**Pipeline and Hazardous
Materials Safety
Administration**

Reference No. 16-0082

This letter is in response to your May 11, 2016, email requesting clarification of the Hazardous Materials Regulations (HMR; 49 CFR Parts 171-180) applicable to the accident damage protection requirements for certain specification DOT cargo tank motor vehicles (CTMVs) found in § 178.345-8. Specifically, you ask about the requirement for protecting piping, or any device, that if damaged in an accident could result in loss of lading.

Subject: Request for Interpretation

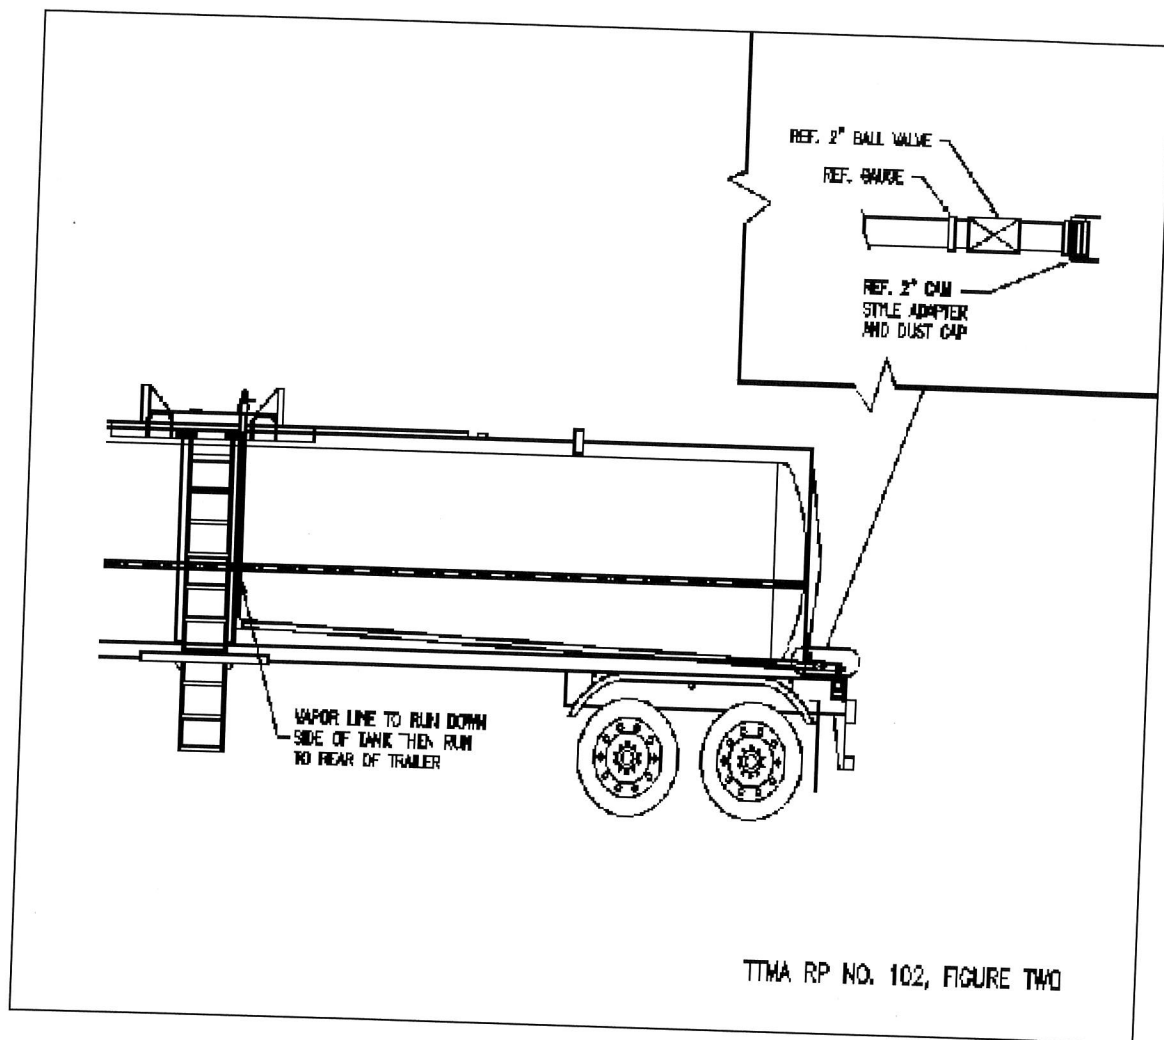
It has come to TTMA's attention that the agency is considering that the requirement for protecting "piping, or any device that if damaged in an accident could result in loss of lading" in §178.345-8(a)(2) includes the dust cap and its arms when evaluating the 6" horizontal set-back rule in §178.345-8(d)(1) even if such are not normally carrying lading. The rationale is that the dust cap and other components are substantial and could transfer significant forces through to areas that do contain lading in transit. See the following photo:

Our concern is if PHMSA views the hand valve and dust cap to be an extension of the piping, which, despite not containing lading during transit, could damage the lading containing portions of the cargo tank; such thinking could be used expansively for other cargo tank piping not associated with the bottom outlet valve shown in the picture.

- A1. Your understanding is correct.
- Q2. You seek confirmation of your understanding that the 6-inch horizontal set-back design, required as part of the rear-end protection provision in § 178.345-8(d)(1), also applies to the dust cap, arms, and hand valves even if these elements do not normally carry lading during transit.

- A2. Your understanding is correct. The dust cover and hand valve must be included in the 6-inch horizontal set-back design as they are part of the piping system. However, if the piping includes a stop valve and a sacrificial device such as a shear section, then the piping is considered protected.

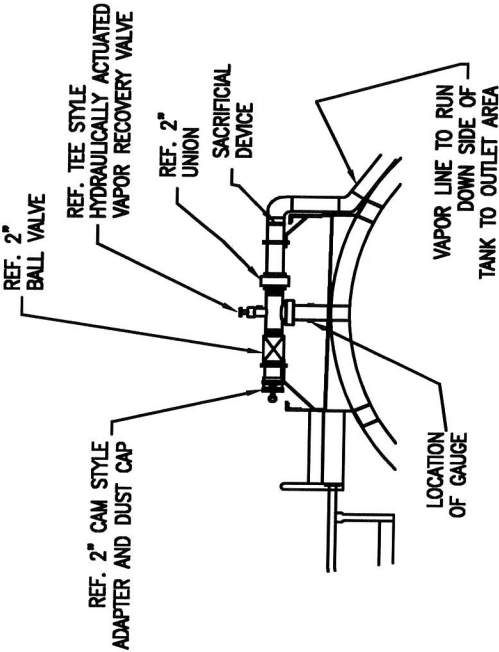
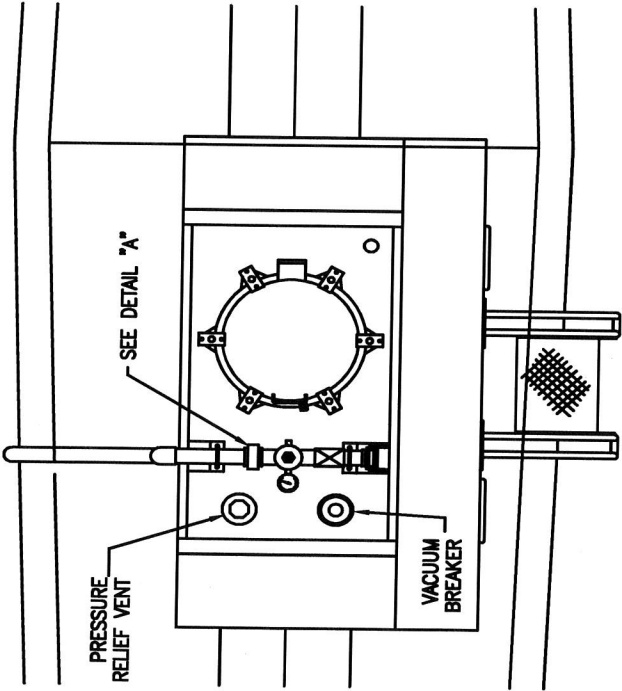
Compressed air and vapor lines are often run to the top of the cargo tank to provide ground level access points for operators as a safer alternative to ascending the ladder of the cargo tank with hoses to either inject air or remove vapors. A common industry practice is shown in the accompanying illustration:

As can be seen in the drawing, the piping involved does not pose a risk of tank puncture in a rear end collision: it is both too long and narrow to transfer significant accident damage loads into the shell of the tank, and it is protected by a sacrificial segment as it enters the overturn protection.

We would like you to clarify that the "piping or any devices that if damaged in an accident could result in a loss of lading" referred to in §178.345-8(a)(2) does not include air or vapor lines installed according to good industry practice such as that described in TTMA RP 102. (copy attached) Further, that the 6" set-back provisions contained in §178.345-8(d)(1) also do not apply to these air or vapor lines.

- A3. The answer is no. The provisions in § 178.345-8(a)(2) do not apply to piping that if damaged in an accident could result in a loss of lading from the cargo tank but is not required by the applicable specification.
- Q4. You ask whether the 6-inch set-back provisions contained in § 178.345-8(d)(1) apply to the air and vapor lines mentioned above.
- A4. The answer is no. The rear-end cargo tank protection device requirements contained in § 178.345-8(d)(1) do not apply to piping that if damaged in an accident could result in a loss of lading from the cargo tank but is not required by the applicable specification.
